Near-term Task Force Recommendation 2.1 Seismic Hazard Evaluation

Hatch Units Nuclear Plant

Sarah Tabatabai
Office of Research
June 26, 2014

Epistemic Uncertainty in Vs

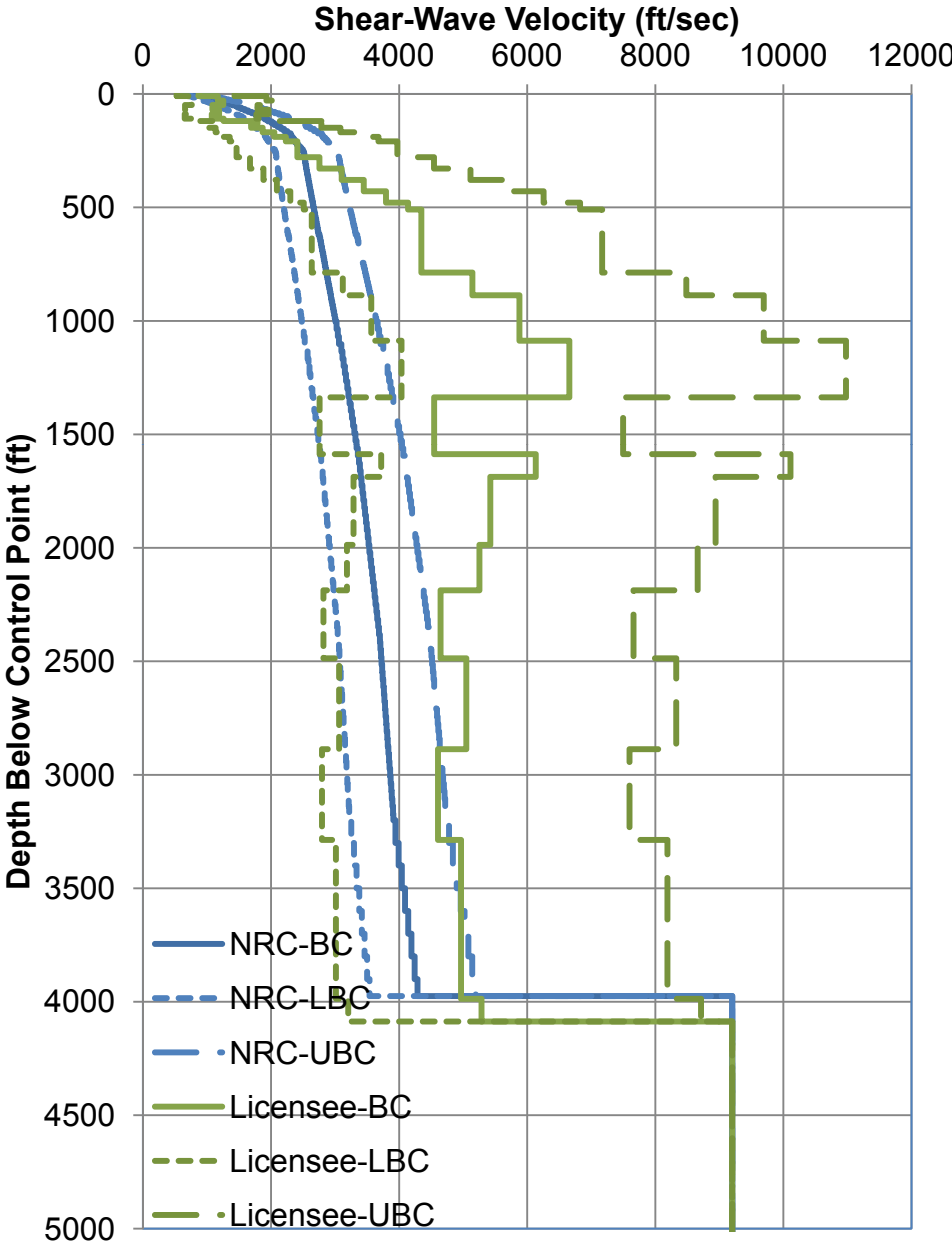
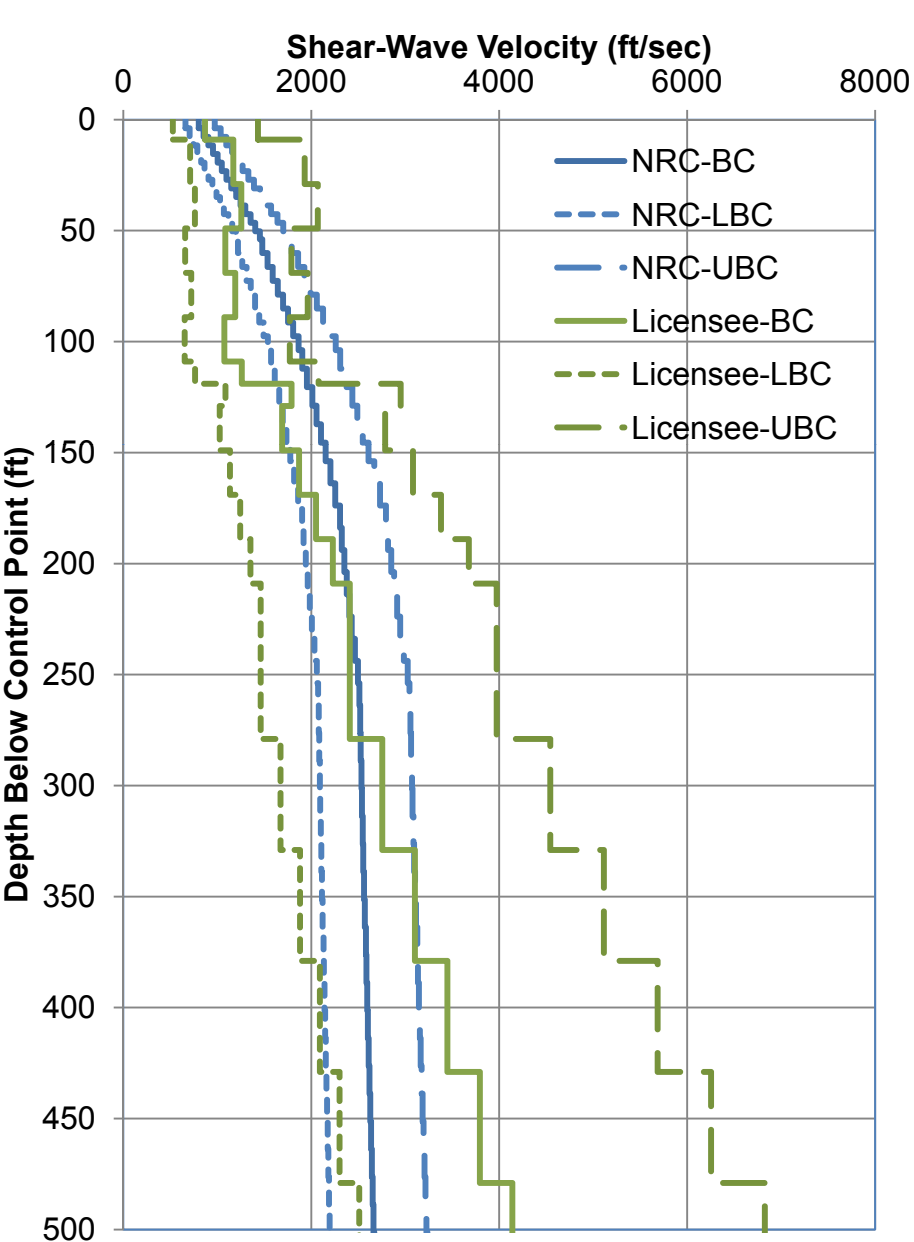
Applied a scale factor of 1.2 to the base case profile for development of the upper and lower case profiles

Applied a scale factor of 1.57 to the base case profile for development of the upper and lower case profiles

Vs Profiles

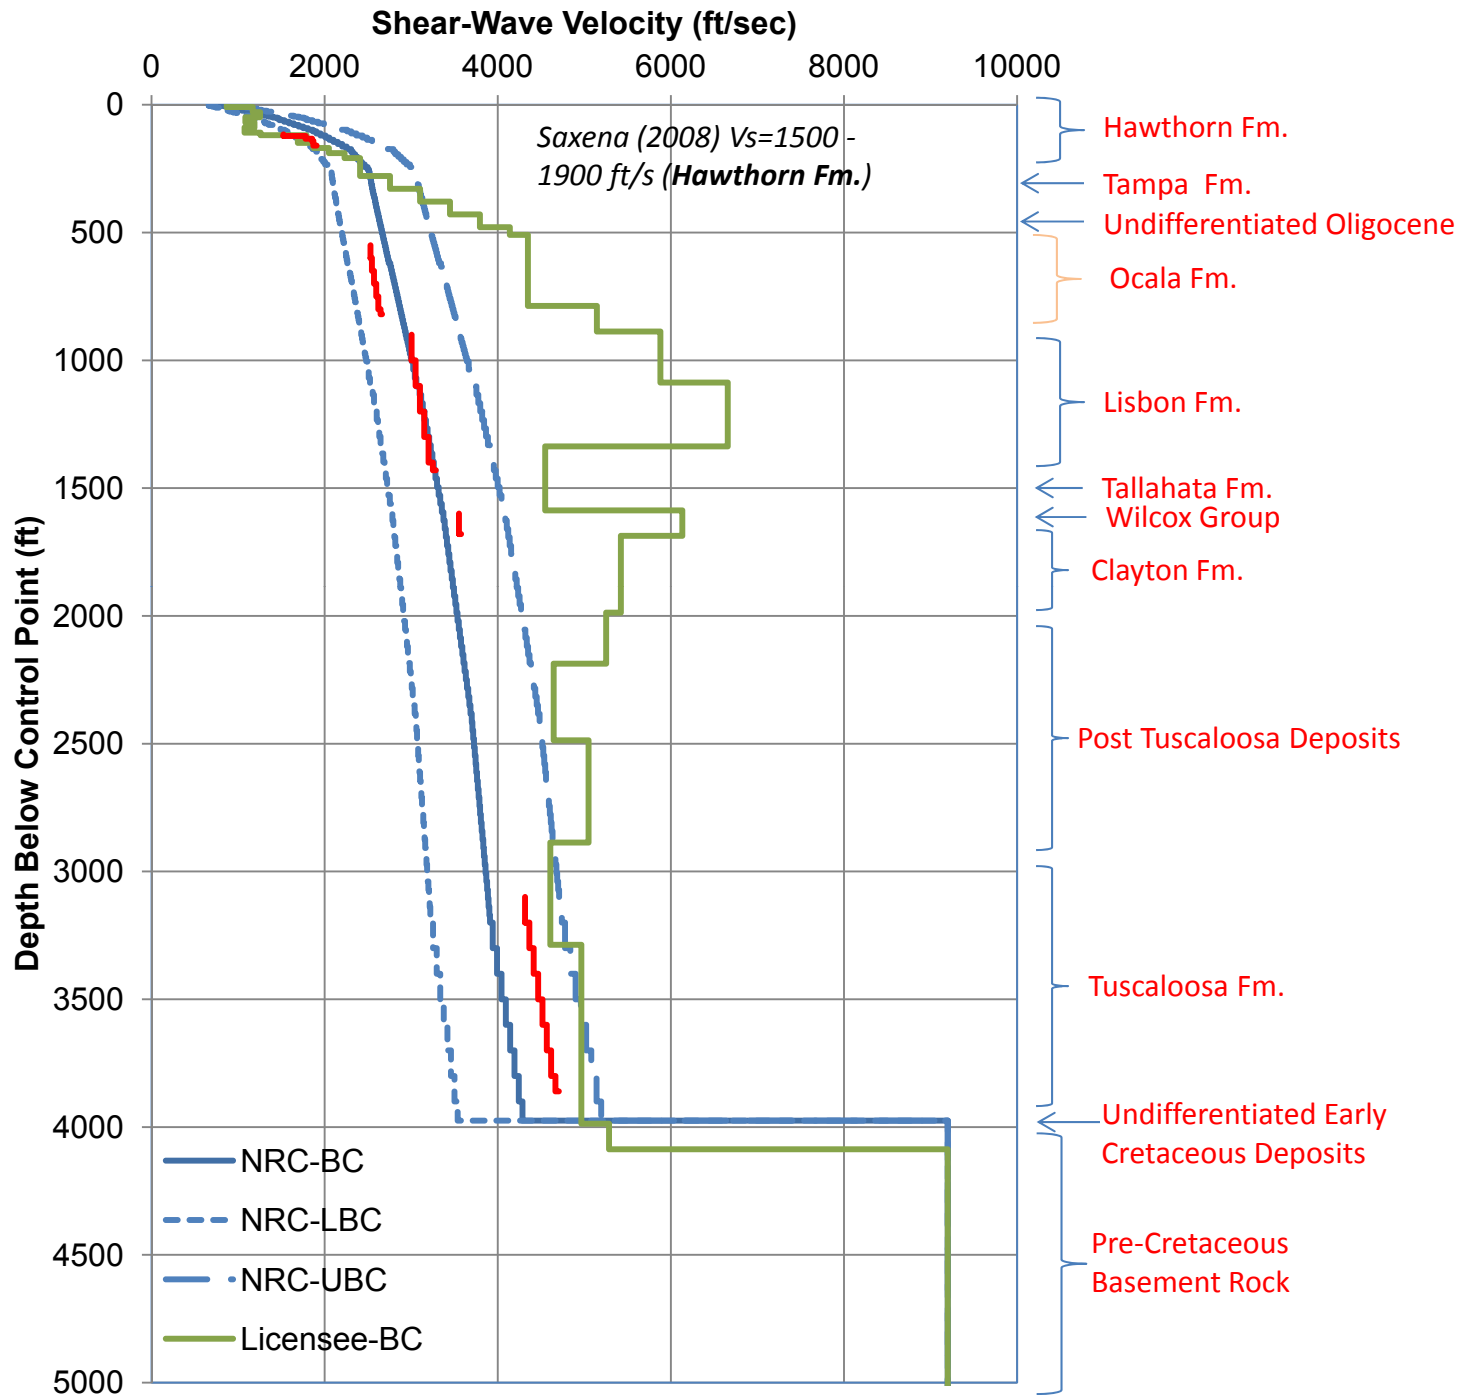
V_s=2450 ±200 ft/s in upper 50-100 ft (FSAR)

Parker (2008) *V_s*=2296 ft/s (Ocala Fm.)

Vogtle COL: *V_s*=2650 ft/s at 149 ft (Lisbon Fm.)

Odum et al (2003):
V_s=2805 ft/s at 98 ft (Wilcox Group)

Odum et al (2003):
V_s=2840 ft/s at 98 ft (Tuscaloosa Fm.)

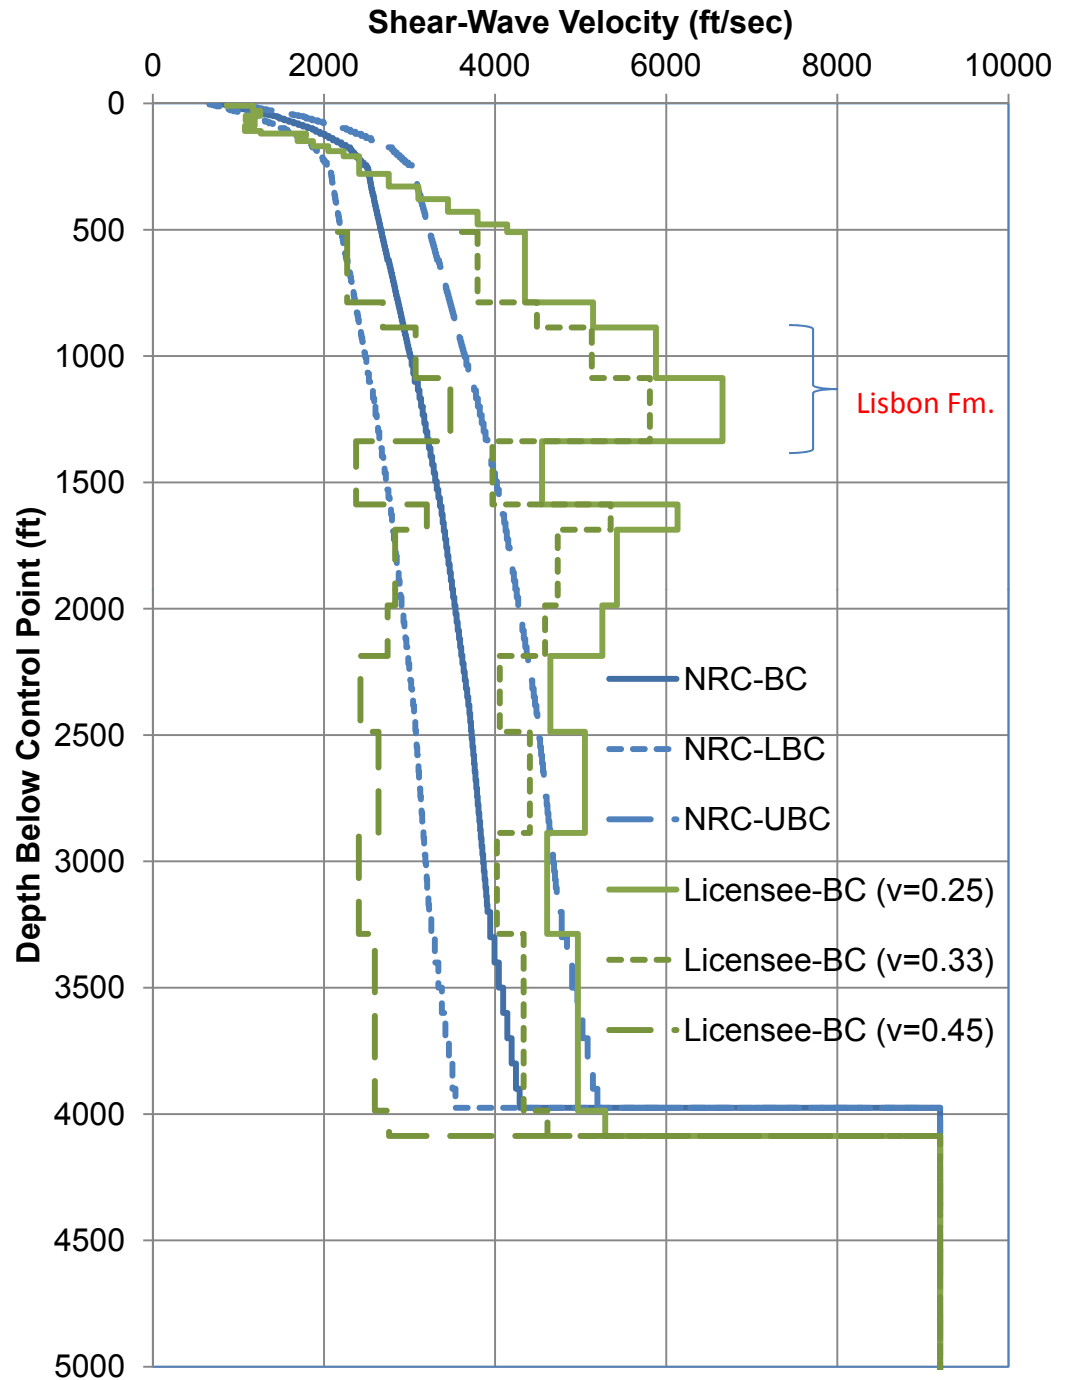
An average Poisson's ratio of 0.43 is reported for the Lisbon Formation at the Farley site

Kappa and Epistemic Uncertainty

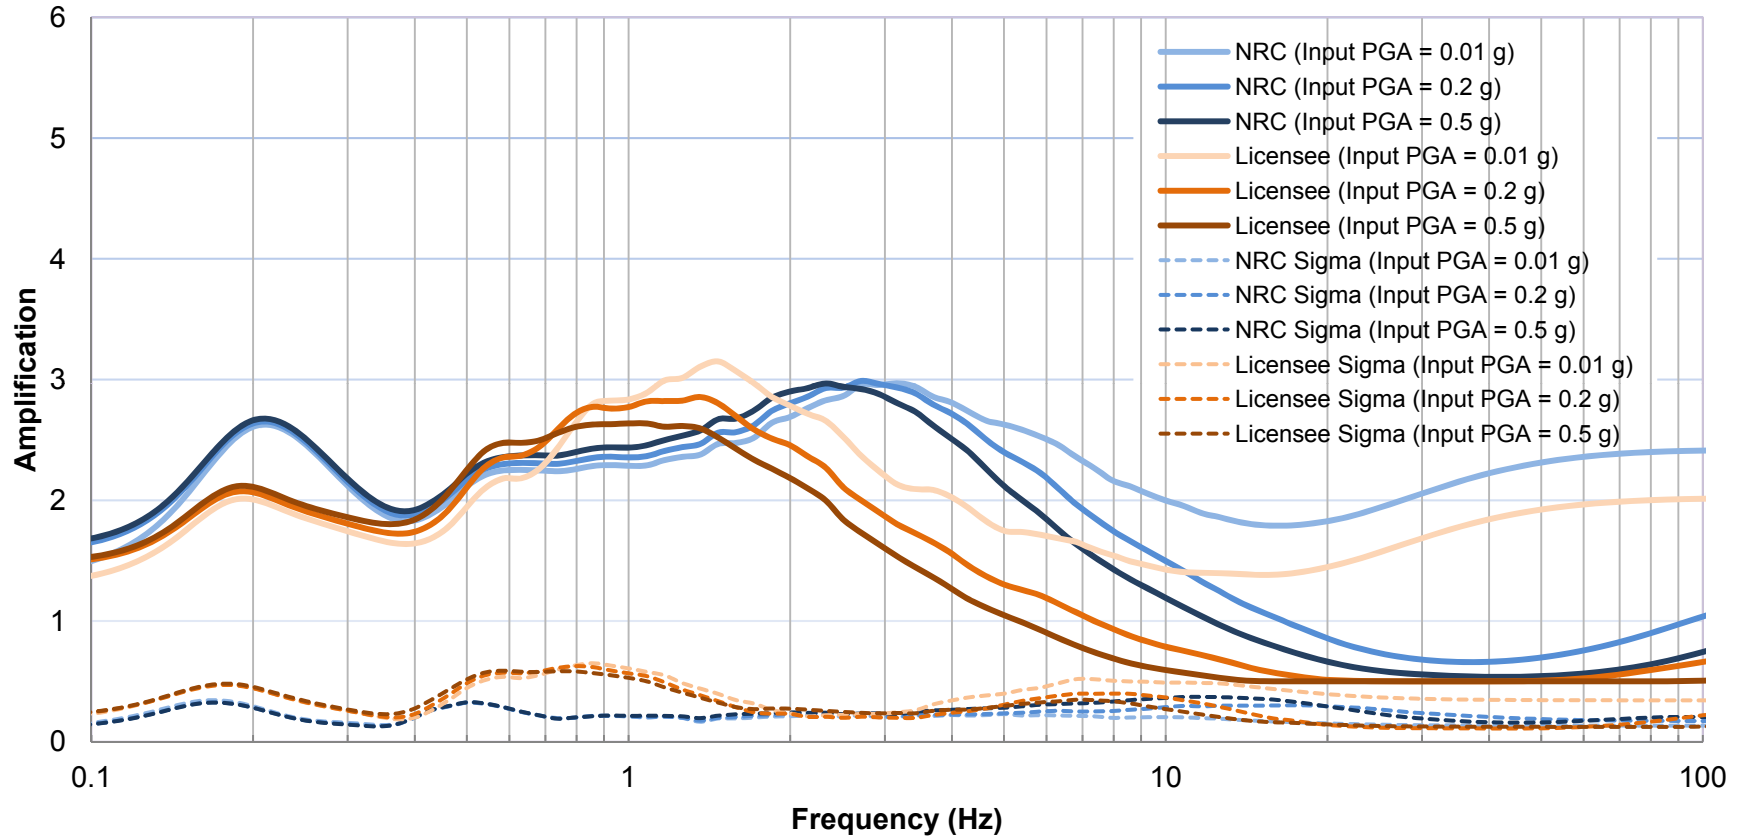
Kappa was calculated for each base case profile using Q values from Campbell (2009). A $\sigma_{in}=0.2$ was applied to determine the range of kappas for each base case profile.

Calculated a kappa distribution² for each base case Vs profile based on a median kappa of 0.04 sec (i.e. a deep soil site) and a $\sigma_{in}=0.4$

¹Imposed an upper limit of 0.04 sec based on the SPID Guidance

²Clarification needed

GMRS Comparison

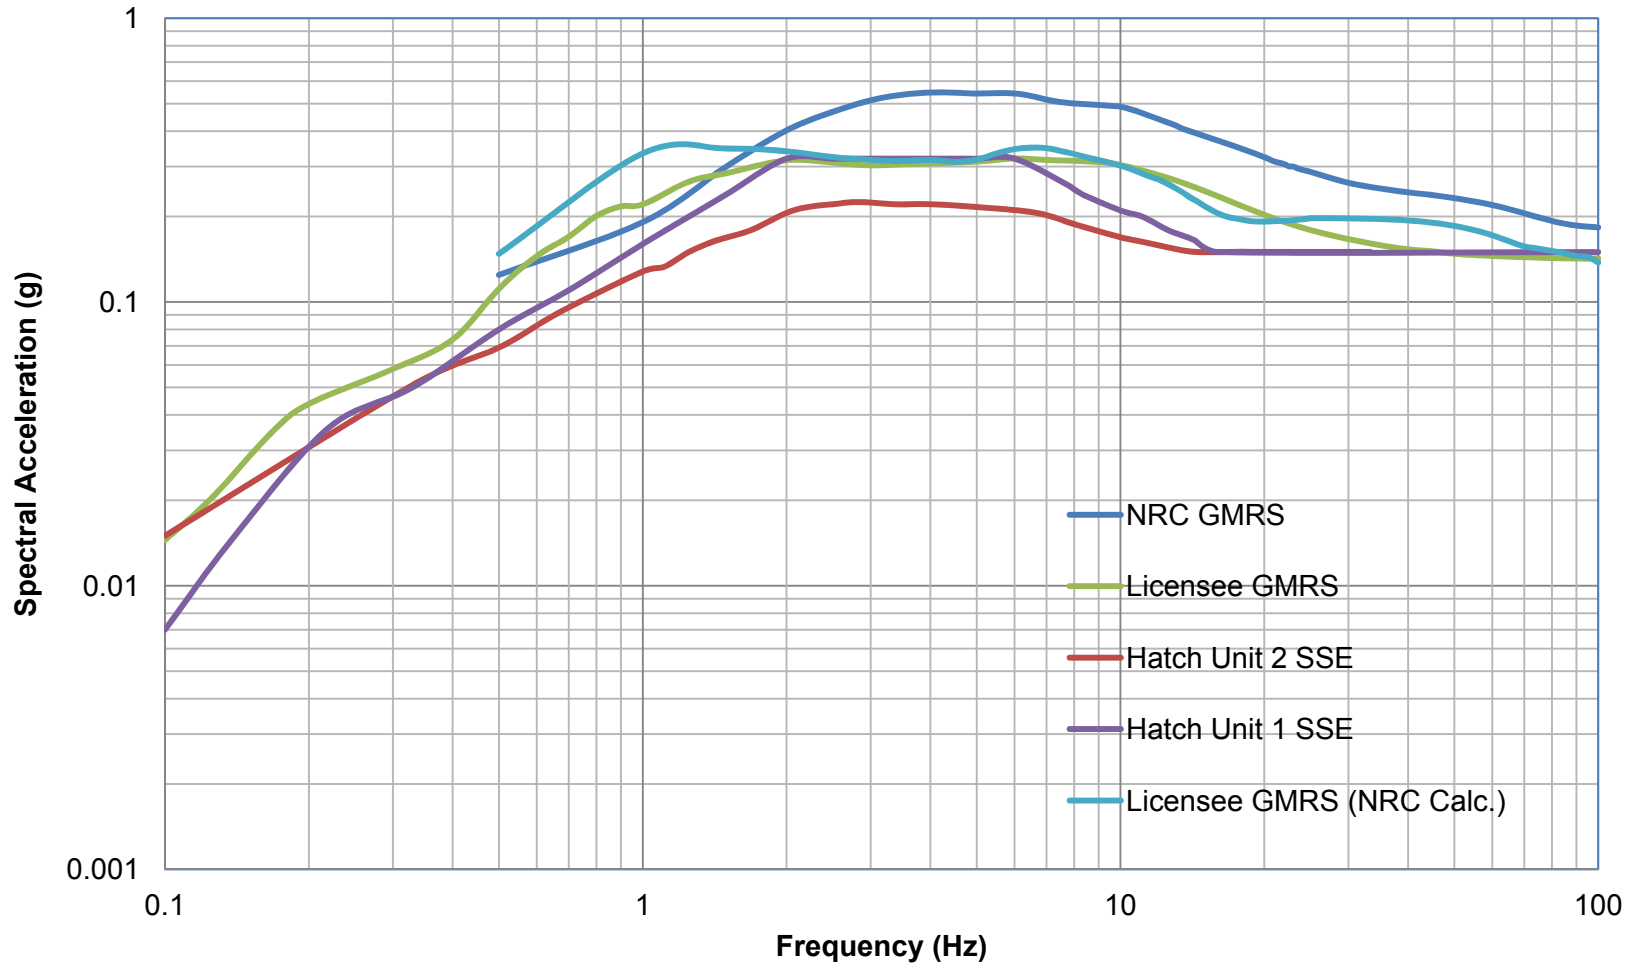
- Kappa
 - Southern considered Hatch to be a deep soil site and used a median kappa of 0.04 sec, while the NRC placed an upper limit of 0.04 sec on kappa
 - Classification as a deep soil site inconsistent with V_s base cases
- Large differences in shear-wave velocities below a depth of approximately 500 ft due to an assumed Poisson's ratio
